Access Compliance Report

Public Rights-of-Way

Intersection ID: 10022282	Main Street: CAMBRIDGE BELTWAY DR	Cross Street: N/A	Location: W
ADA ID: 276BE0D988D8	Ramp Type: PerpDiag	Initial Pass/Fail: Fail	Overall Compliance: No
Codes/Mitigation Info/Possible Solution		Field Measurements/Component Compliance	
Severity Score: 12.5

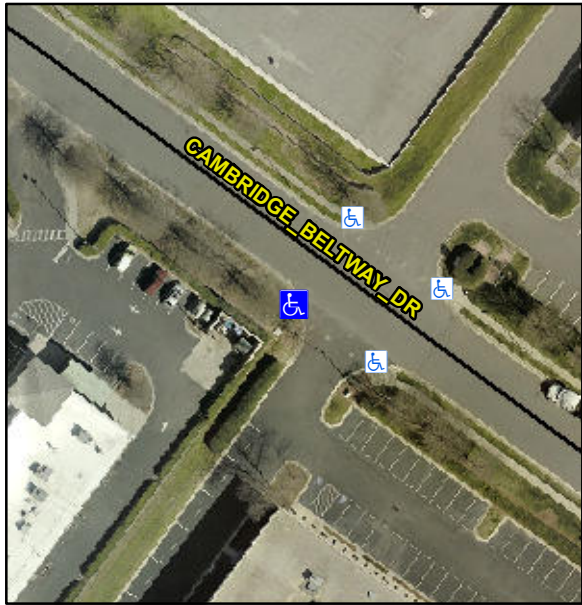
Compliance	Description	Data	Compliance	Description	Data
N/A	Ramp Length (in)	44.0	No	Ramp Slope (%)	9.3
Yes	Ramp Width (in)	48.0	Yes	Ramp XSlope (%)	1.2
N/A	Flare Type LT	N/A	N/A	Flare Type RT	N/A
N/A	Flare Slope LT (%)	N/A	N/A	Flare Slope RT (%)	N/A
N/A	Flare Traversable LT?	N/A	N/A	Flare Traversable RT?	N/A
N/A	Landing Length (in)	N/A	N/A	DWS Provided?	N/A
N/A	Landing Width (in)	N/A	N/A	DWS Contrast?	N/A
N/A	Landing Slope (%)	N/A	N/A	DWS Length (in)	N/A
N/A	Landing X Slope (%)	N/A	N/A	DWS Full Width?	N/A
N/A	Landing Curb? (Y/N)	N/A	N/A	DWS Offset (in)	N/A
N/A	Shared Landing?	N/A			
N/A	Gutter Ponding?	N/A	N/A	Gutter Slope (%)	N/A
N/A	Gutter Lip Ht (in)	N/A	N/A	Gutter X Slope (%)	N/A
N/A	Painted X Walk1?	No	N/A	Painted X Walk2?	No
	X Walk 1 Direction	To SE		X Walk 2 Direction	To NE
N/A	X Walk 1 Width (in)	N/A	N/A	X Walk 2 Width (in)	N/A
	X Walk 1 Slope (%)	0.9		X Walk 2 Slope (%)	3.1
	X Walk 1 X Slope (%)	1.9		X Walk 2 X Slope (%)	1.6

Possible Solutions:					
	Remove & Replace Curb Ramp With Two New Directional Ramps or Equivalent.					
	Surveyor Notes:					
	N/A					
	PROW/ADA:					
	R304.2.2					
	Street 1 Name		ENTRANCE			
	Stop Condition-Street 2		StopSign			
	Street 2 Name		CAMBRIDGE BELTWAY DR			
	Stop Condition-Street 1		None			
Total Cost:		\$	3200.00
